CONFIDENTIAL SERVICE PHILCO

RADIO No. 26

DATE: 9-16-41

COMPLETE INFORMATION ON THE 1942 RECORD CHANGERS

FIGURE 1

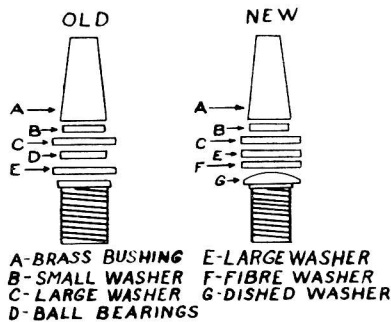
A. The rumble in the Models 42-1010 and 1016 can be easily corrected by replacing the turntable bearing. Remove the turntable and the spindle and then take out the brass cone and the ball bearings and washers. Rebuild the bearing, using the old washers and the new flat fiber washer and the concave steel washer. (See Figure 1). Add "Stay-Put Grease" or "Lubriplate" between the washers to eliminate friction. When replacing the spindle assembly, the spindle must be more than $\frac{1}{2}$ turn loose while lining it up with the record support shelf.

FIGURE 3

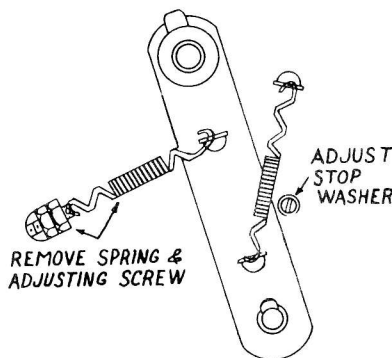
Remove the regeneration spring and the threaded adjusting screw and nuts. (See Figure 3).

There is a small fiber washer which is used to limit the motion of the upper bearing support assembly. (See Figure 3). Loosen the screw holding this eccentric washer. Hold the vertical drive shaft at approximately 3° to the right of perpendicular and adjust the washer and fasten in place. (See Figure 6).

FIGURE 4

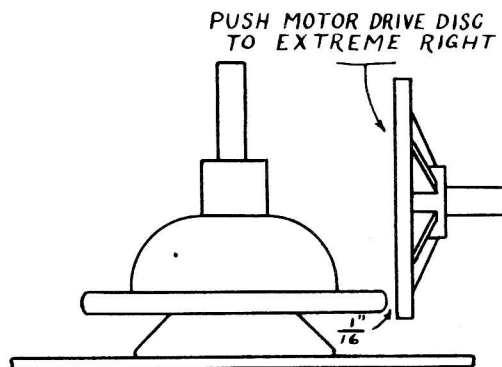
Push the motor drive disc and armature to the extreme right, against the thrust spring. Allow $\frac{1}{16}$ " clearance between the rim of the bell drive disc and the motor drive disc and tighten the two bearing screws securely. (See Figure 4).

FIGURE 5

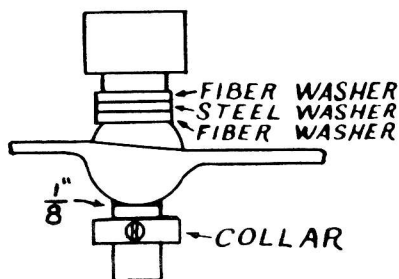
The change consists of removing the cupped washer and the flat washer below the upper bearing plate and adding two fiber washers, one on each side of the steel washers above the oilless bearing. The collar should be reset allowing approximately $\frac{1}{8}$ " clearance between the collar and the upper bearing support. The oilless bearing should seat in the upper bearing support and should not turn with the vertical shaft. (Figure 5).
